UNITED STATES NUCLEAR REGULATORY COMMISSION WASHINGTON, D. C. 20555

October 1, 1980

Docket No. 50-409

COMMENTS ON LA CROSSE BOILING WATER REACTOR RADIOLOGICAL EFFLUENT TECHNICAL SPECIFICATIONS (RETS)

Figure 3.11-1

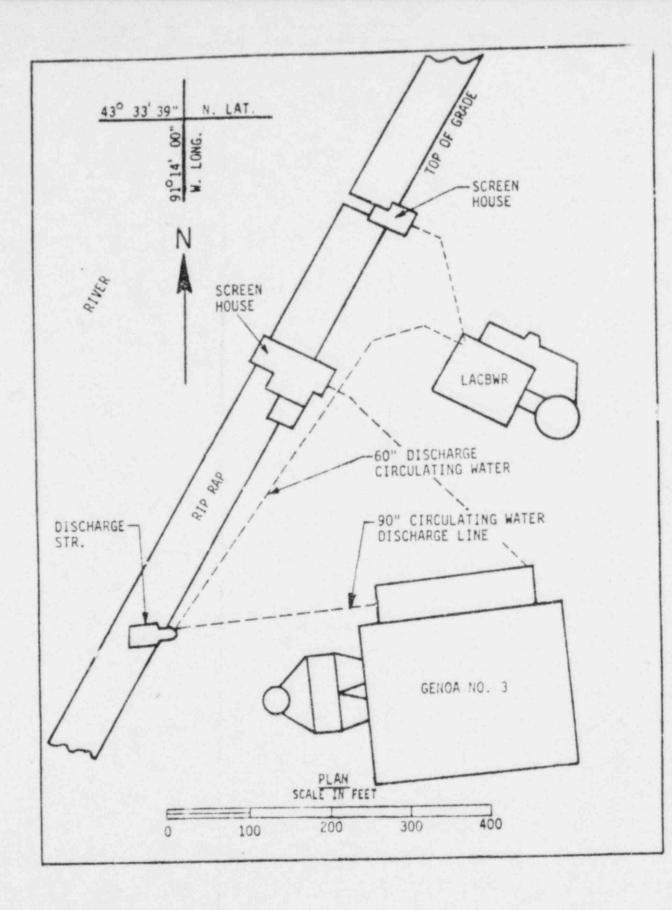
- 9. Revise Figure 3.11-1. This figure shall consist of a map of the site area showing the perimeter of the site and locating the points where liquid effluent leaves the site. If on-site water areas containing radioactive wastes are utilized by the public for recreational or other purposes, the points of release to these water areas shall be identified. The figure shall be sufficiently detailed to allow identification of structures near the release points and areas within the site boundary where ground and surface water is accessible by members of the general public. See NUREG-0133 for additional guidance.
